Construction Environmental Management Plan (CEMP) Broken Hill Solar PV Power Station

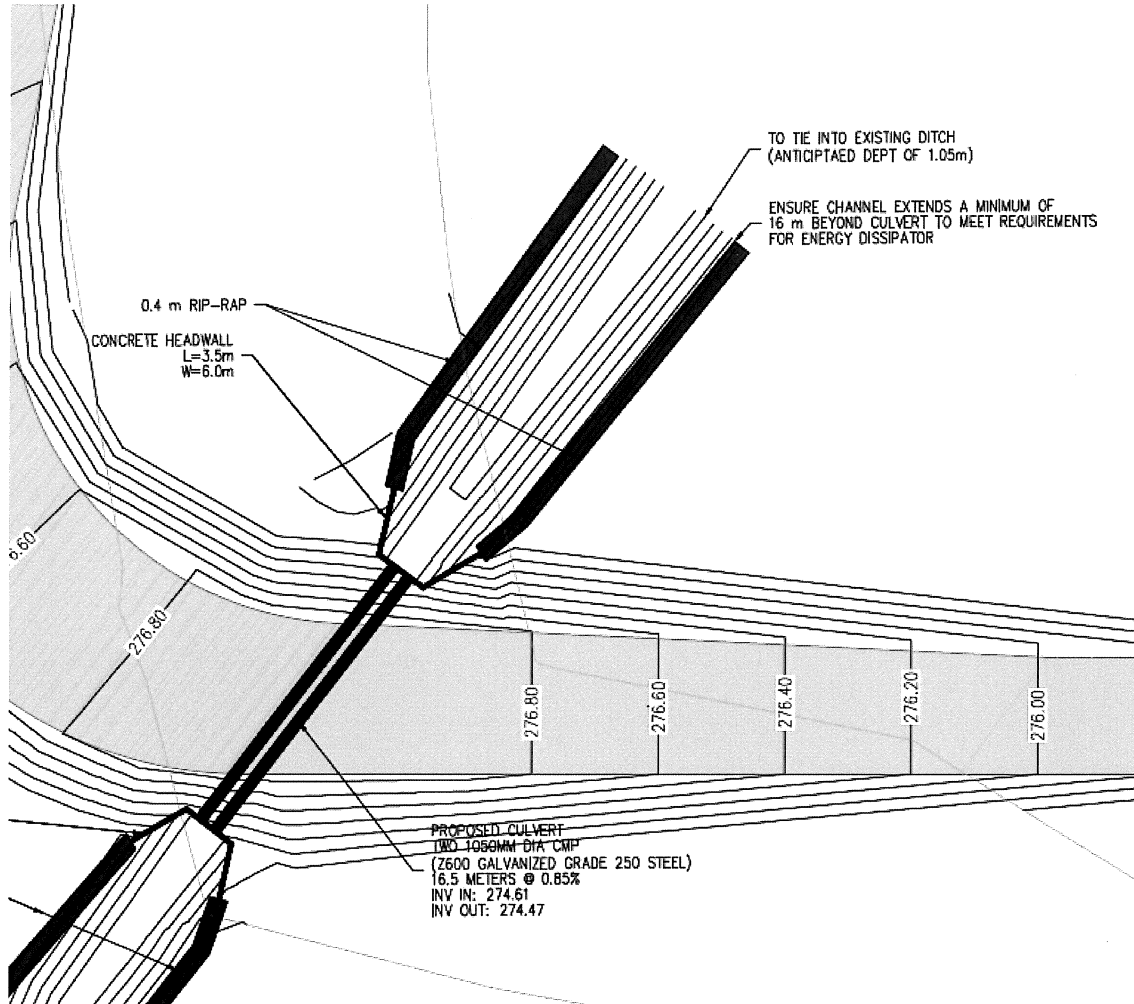
- Clarification is requested of the proposed sediment and erosion control and rehabilitation measures within the proposed drainage trenches and whether there is a requirement for check dams and/or sediment basins.
- Clarification is requested of the proposed sediment and erosion control measures on the downstream side of each proposed culvert. Drawing ABH1-C346 indicates rock rip rap on the bank to 0.4m however there is no indication of measures proposed on the bed of the drainage line. The Guidelines for Controlled Activities on Waterfront land recommend the use of a scour apron on the bed of the drainage line to mitigate bed erosion and to dissipate flow velocity.

An example of the channel arrangement including road culvert and requirements for energy dissipation is provided below (and also Drawing ABH1-C346 Appendix E). The soil and water management details are shown in Drawing ABH1-C811.

The drainage channels will be lined with rock in entirety as per Landcom (2004) (Blue Book) Guidelines to cover the channel banks and bed and reduce the erosive energy of flow.

Figure 8.3: Rural AUL(S) treatment with a short left-turn lane

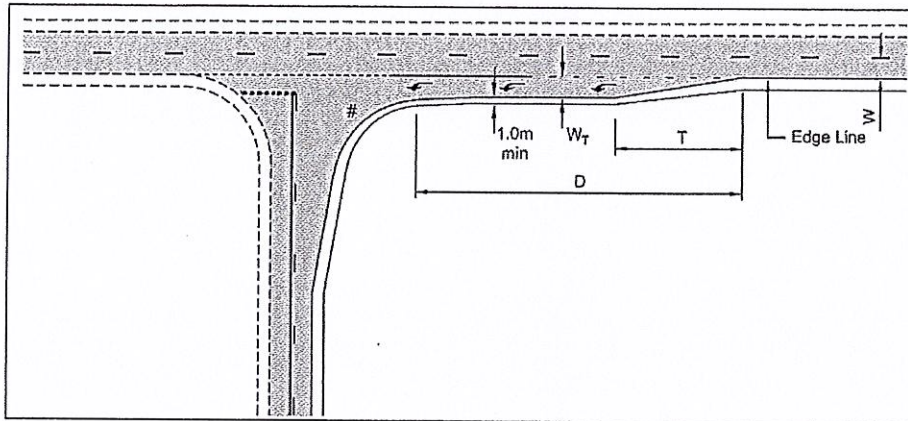
Note: Roads and Maritime is willing to consider a shorter left turn treatment than required under Figure 8.3 of Austrroads Guide to Road Design 2010 – Part 4A to negate the widening of the culvert and associated infrastructure east of the site access intersection with the Barrier Highway.
